March 19, 2020
Delivered via email
To: The Encinitas Planning Commission

Re: Moonlight Residence Case #MULTI-002926-2019, 100 Fifth Street

Attachment PC-9, page 182

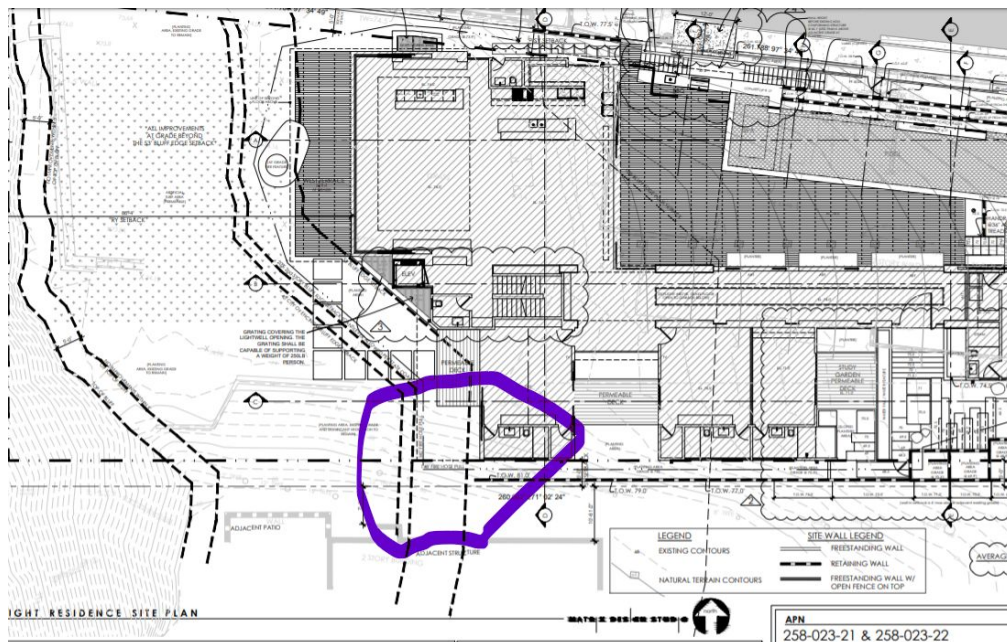
In addition, the retaining wall included in the proposed project along the southern boundary as shown in the Planning Commission Agenda Report (and in the site plan drawings) appears to be very close if not on the setback limit and could thus constitute a form of shoreline protection for new development. Coastal Act Section 30253, as cited above, prohibits this wall and any development it is designed to protect.
